**Draft Environmental Impact Statement/Environmental
Impact Report Errata**

DRAFT EIS/EIR ERRATA

This Errata corrects or clarifies known errors that were in the *Westside Subway Extension Draft EIS/EIR* released for public review on September 3, 2010. Items in this Errata reflect changes associated with all Alternatives discussed in the Draft EIS/EIR with the exception of those specific to Alternative 2. On October 28, 2010, the Metro Board approved Alternative 2 (Westwood/VA Hospital Extension) as the Locally Preferred Alternative (LPA). The LPA was then further refined and analyzed in the Final EIS/EIR. Therefore any changes specific to Alternative 2 from the Draft EIS/EIR were reflected in the Final EIS/EIR. It is important to note that none of the following corrections change the Draft EIS/EIR findings for any of the Alternatives regarding transportation, environmental, community or cultural impacts.

Figure 3-18. Station/Bus/Pedestrian-Bicycle Impact Analysis—Wilshire/Crenshaw Station

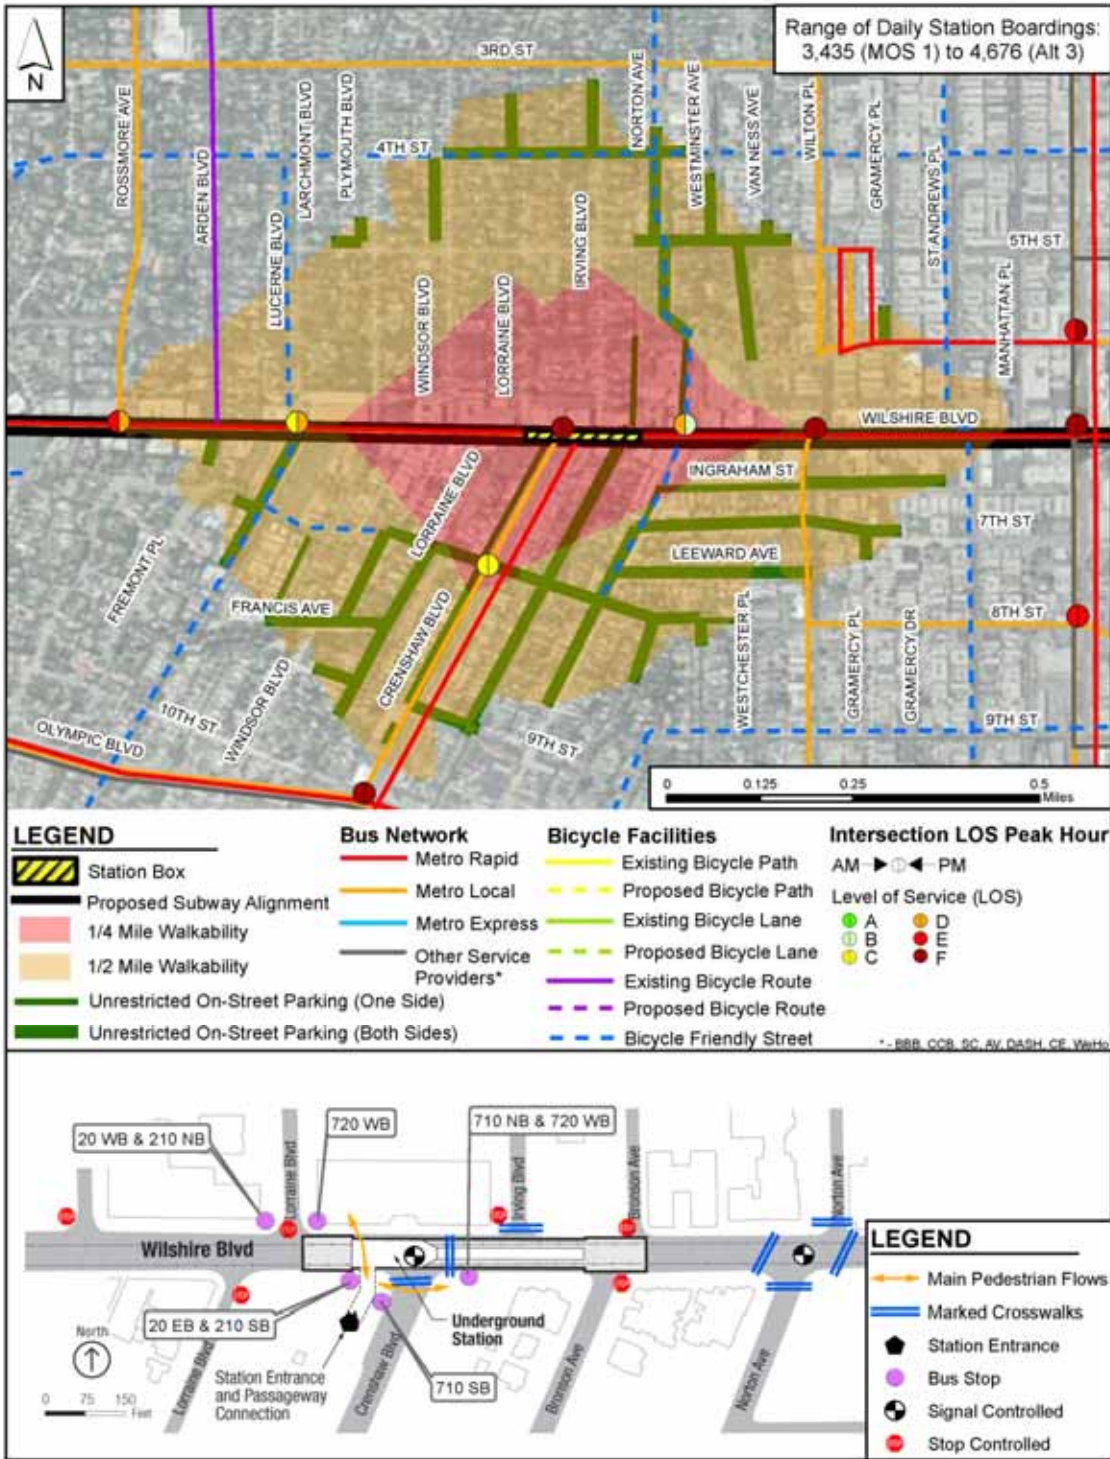
Change The following is a modification of and replaces Figure 3-18.

Figure 4-59. Parklands and Community Facilities (Wilshire/Bundy Station to Wilshire/4th Station)

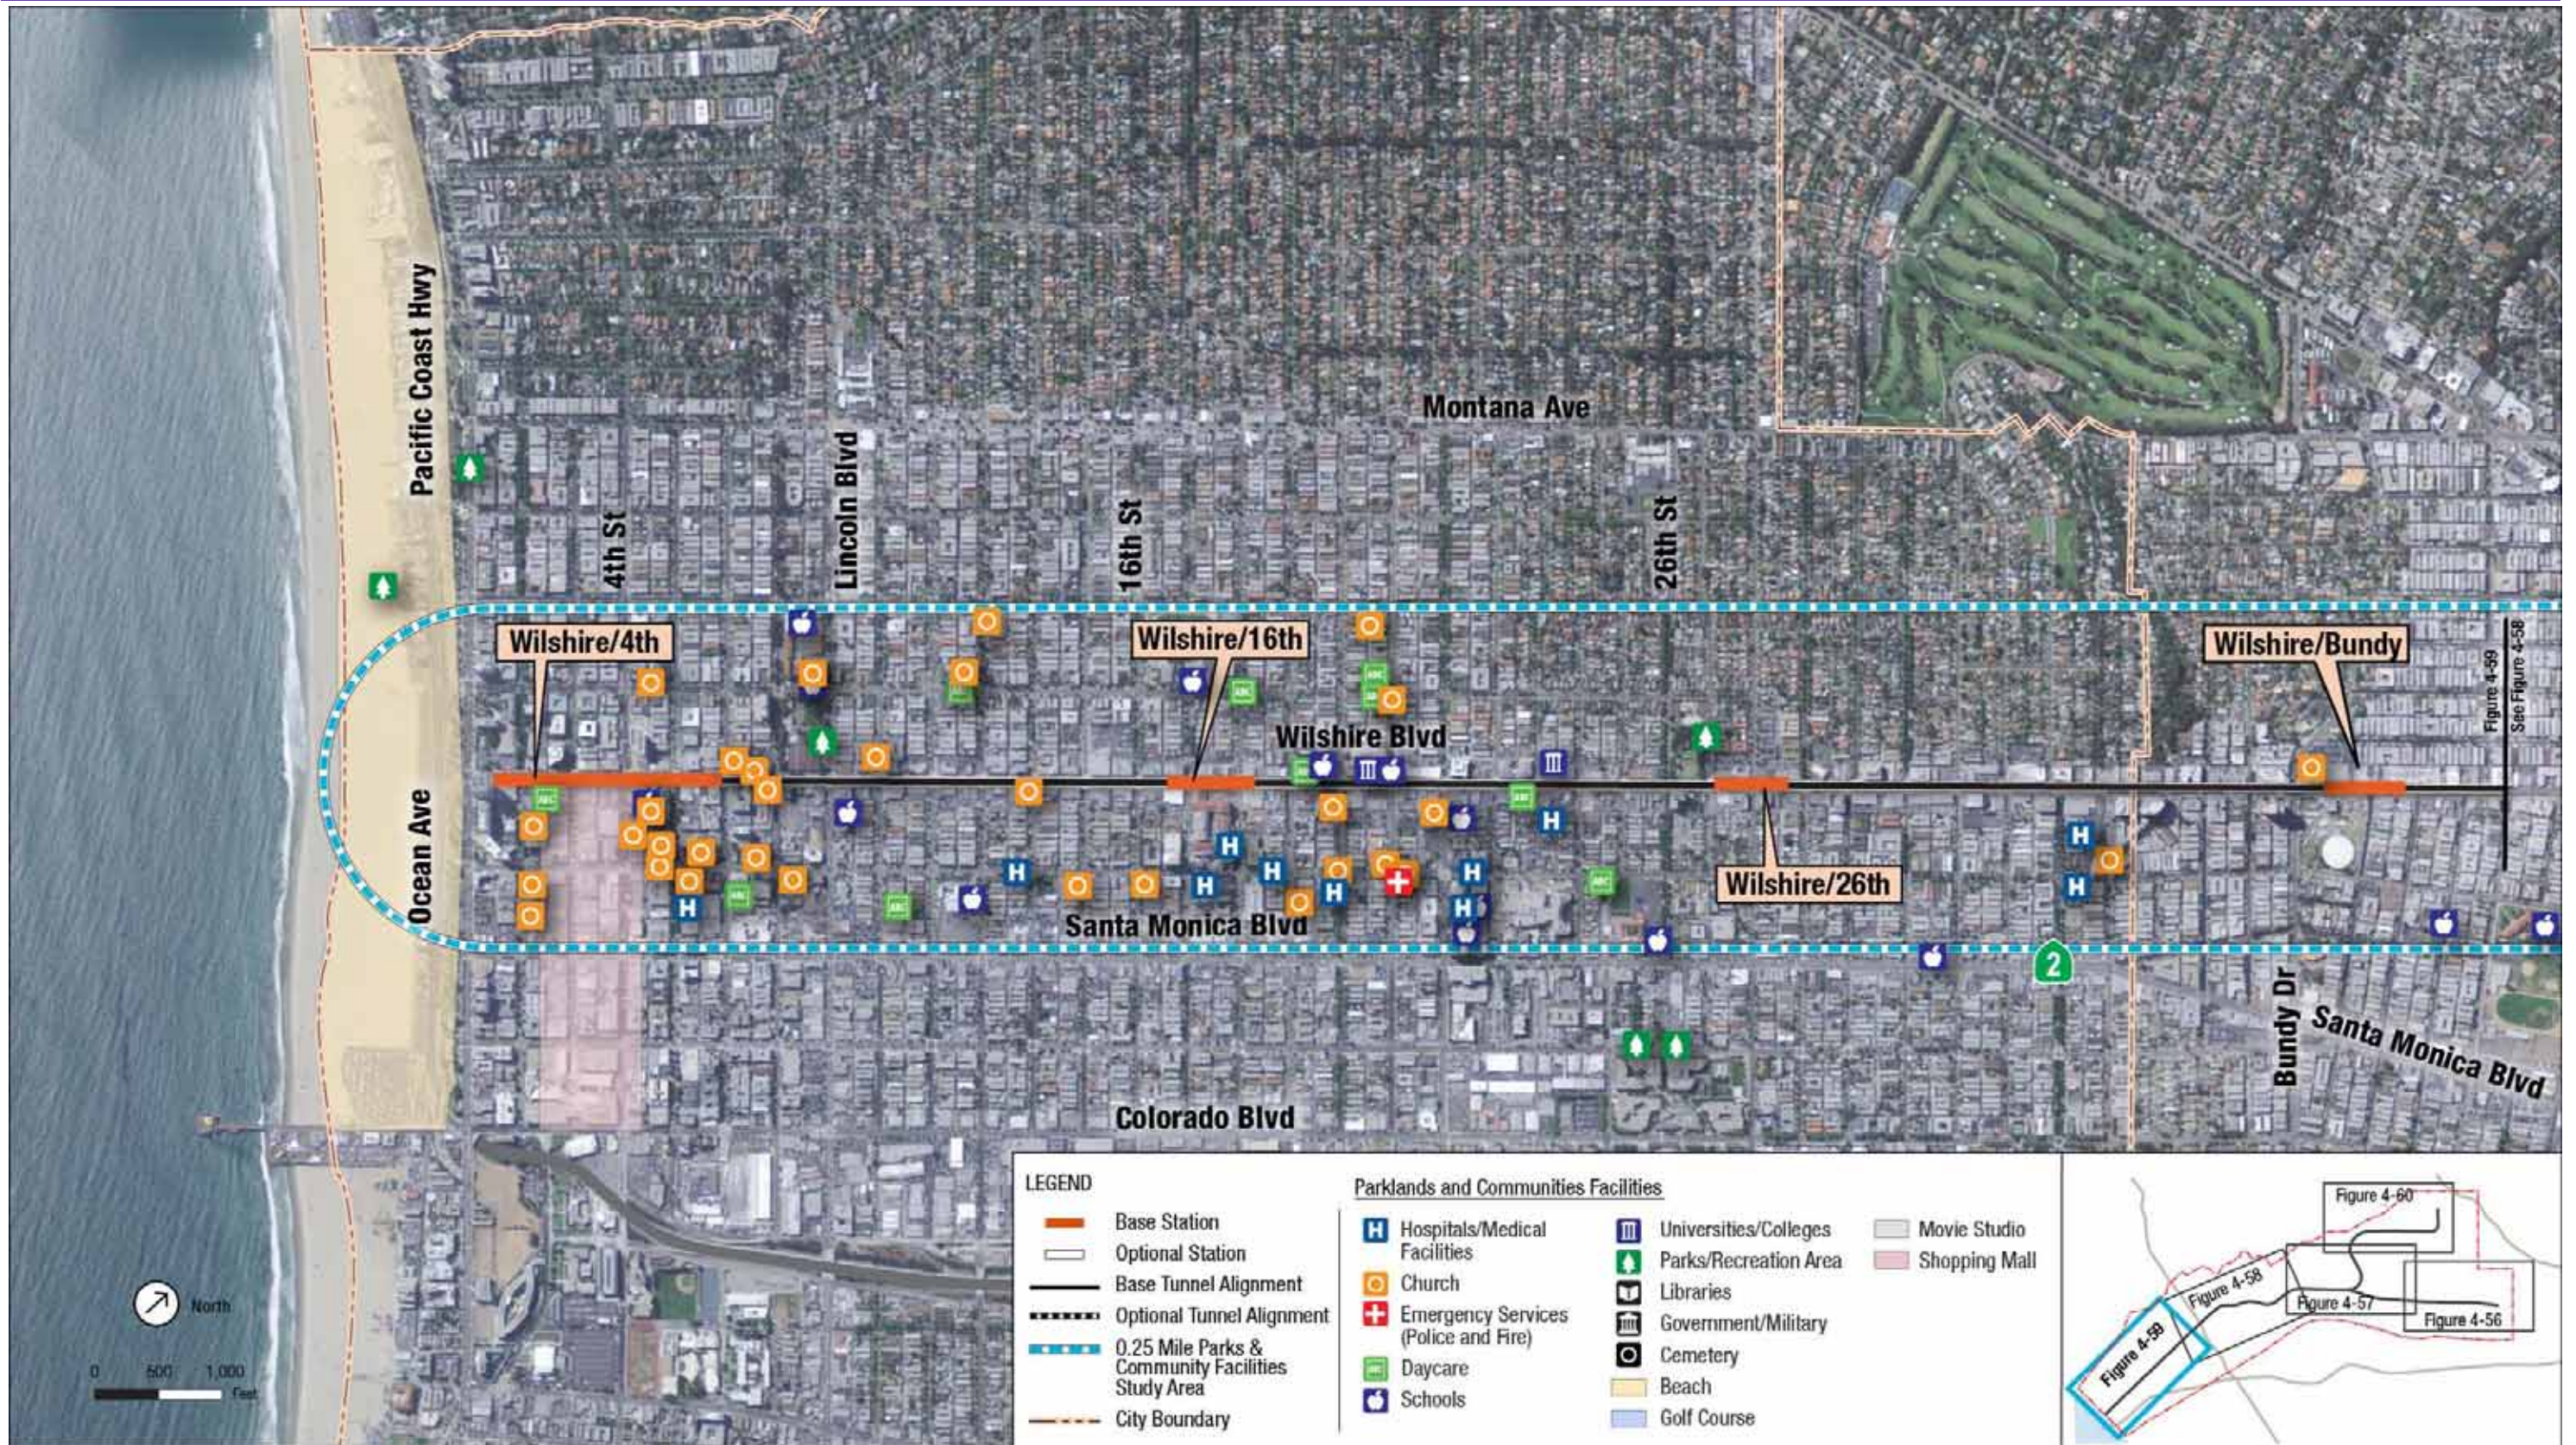
Change The following is a modification of and replaces Figure 4-59.
